## Heritage Interpretation | Strong Room - Updated Interpretation | The Lands SSD7484 - MOD 21

Freeman Ryan Design (FRD) has been engaged to provide Heritage Interpretation in the Lands by Capella Building.

Umbrella Mechanism in the Lowered Position

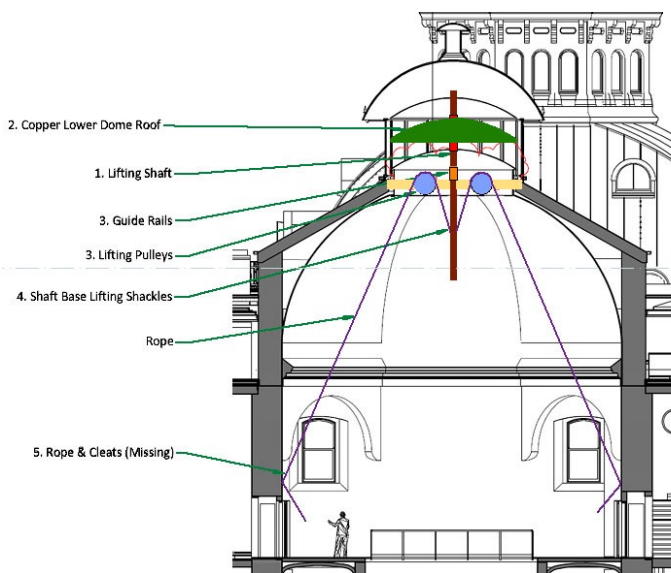
- Level 1 Panel 2.2 – the text should reflect that some of the strong room shelving has been retained in-situ (as required by consent condition C26).
- Generally the text should be clear that the strong room remains spatially intact and that the text is not referring to a feature that has been removed. Will the space continue to be known as the strong room?
- Highlight the umbrella mechanism as a unique feature to this building.
- Include a clearer description of the operation of the umbrella mechanism, which allowed the internal copper dome to be raised or lowered. ‘Retracted’ and ‘closed’ don’t adequately describe how it worked. Illustrations of the internal dome in open and closed positions would help to describe the feature.
- Check all descriptions of the Strong Room and its features for accuracy.

The dome's ceiling incorporated an 'umbrella' opening, which is thought to have been raised and retracted to allow daylight and ventilation, and lowered and closed with steel covers, as seen now, to seal the room from fire, enabling the protection of the land survey maps, plans and documents as part of the fire protection measures in the space. Although unconfirmed, it is possible that the 'umbrella' was also intended to be opened to allow the ventilation of smoke and the escape of embers from the building.

It is conjectured that the 'umbrella' opening was operated either manually through ropes and pulleys, or by means of an electric motor; neither of these means survive. The opening and closing of the umbrella mechanism represents a unique feature of the Strong Room and a vital part of its fire protection strategy.

The 'umbrella' opening mechanism in lowered, closed position, as conjectured by Traditional Stonemasonry (Consulting) Pty Ltd, 29 August 2025. © Traditional Stonemasonry (Consulting) Pty Ltd.
